RAINIER SQUARE REDEVELOPMENT RECOMMENDATION MEETING

Design Review Submittal # 2

Address: 1301 5th Ave., Seattle, WA 98101

DRB #2 Review Date: June 23, 2015

4th & Union Corner Options

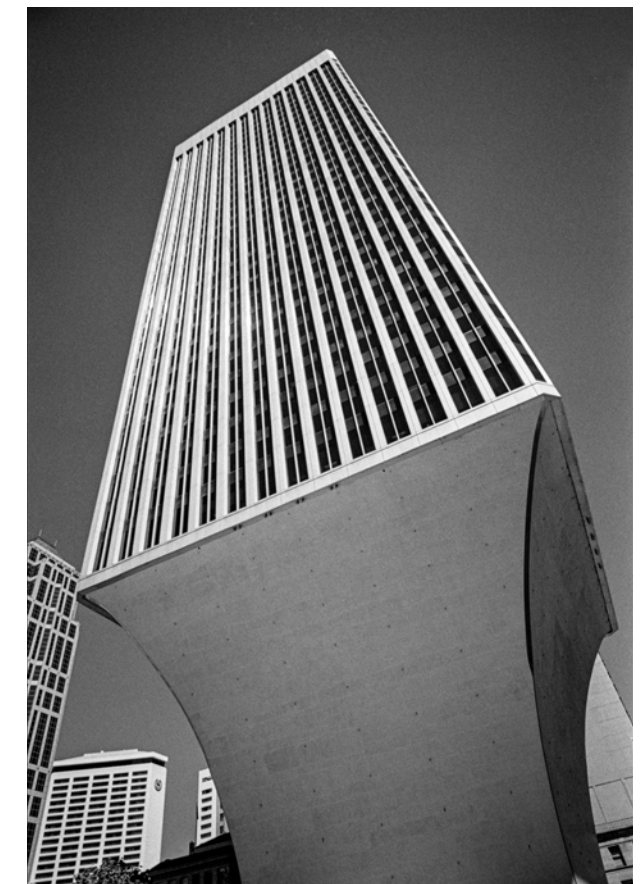
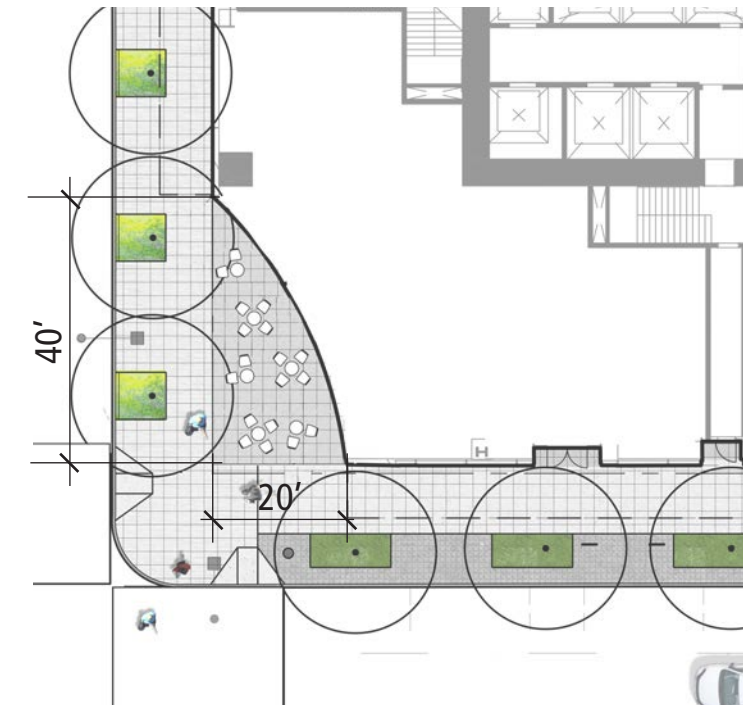
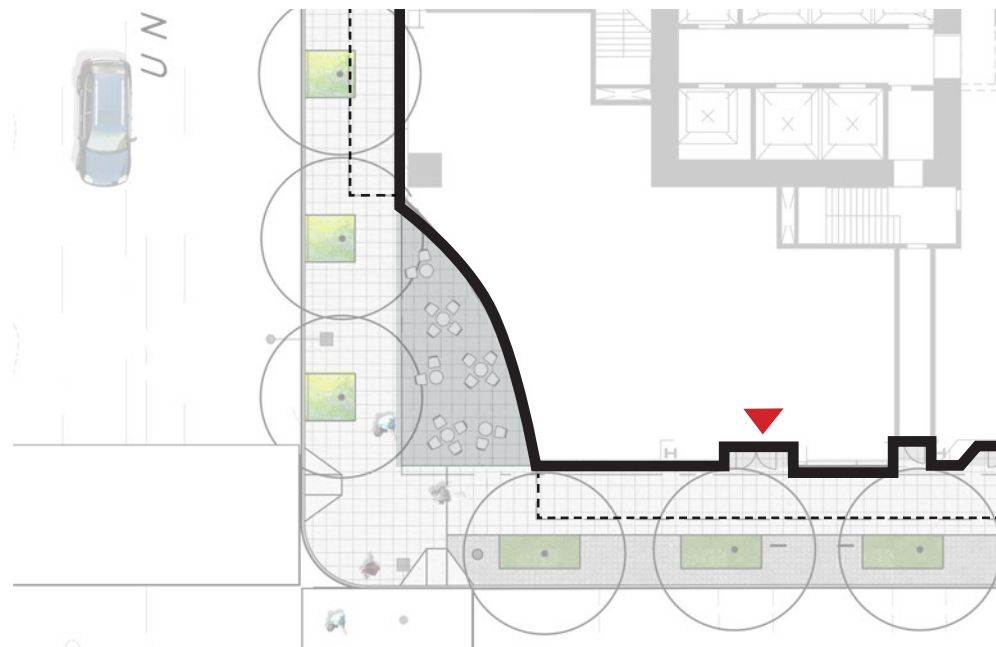
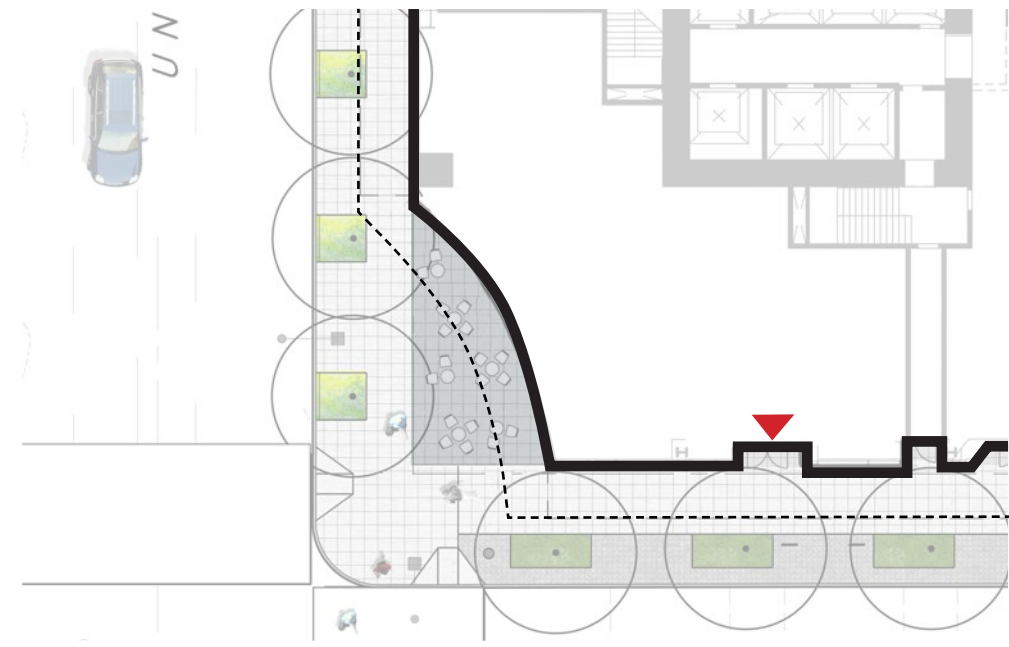
More effort should be applied to creating a common and interesting landscape language at the entries and the tree pits. Street furniture should be added that complements the landscape design. The Fourth and Union corner plaza provides an opportunity for interesting landscaping and the introduction of street furniture.

Our preferred design engages pedestrians and retail visitors with the building by creating a space that allows people to experience the dynamic nature of the building form. The corner is intentionally kept open so that one can move to the base of the building and look up at the dramatic form of the carve. In our preferred design, we have removed the canopy from this space. This enables full, clean, and clear viewing of the sculpted form. However, if the Design Review Board requires that a canopy is placed here, we will provide one (see alternate).

D.4 / D.5 Signage / Lighting

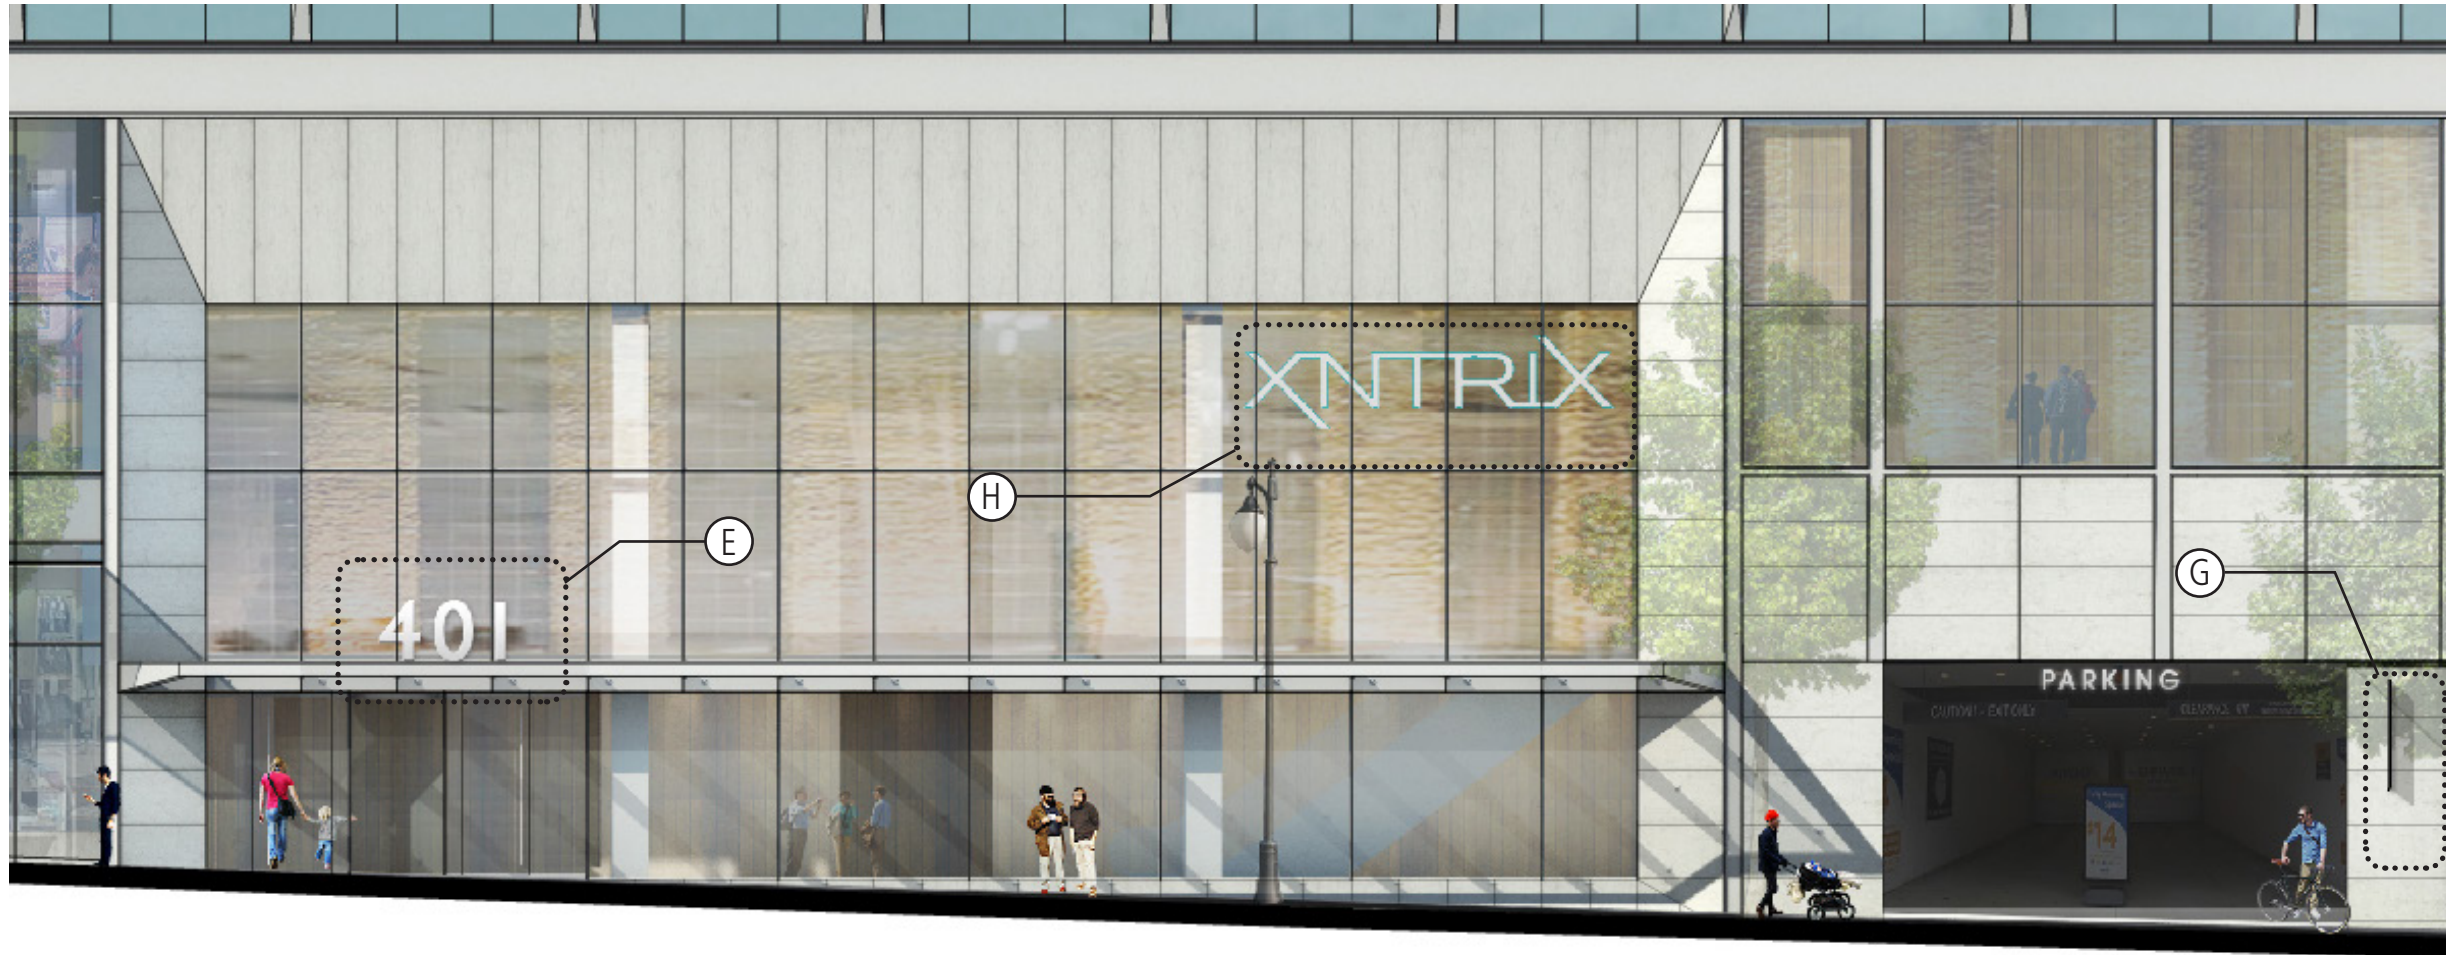
- The Board requested a signage concept plan along with elevations showing the location of signs at the office and retail base. The Board added that signage should not cover the piers that form the hotel.
- Provide special lighting at the hotel entry to enhance the sense of entry.

- Detailed signage, lighting, and retail storefront design information has been provided in response to Board comments.
- On the following pages, more detailed design information has been provided for retail storefront design, residential and hotel entries, signage treatment and locations, and garage entrances.
- Design information has been shown for retail storefront treatment with individualized approaches to merchandise display and brand identity occurring within the overall storefront design vocabulary at the base of the development.
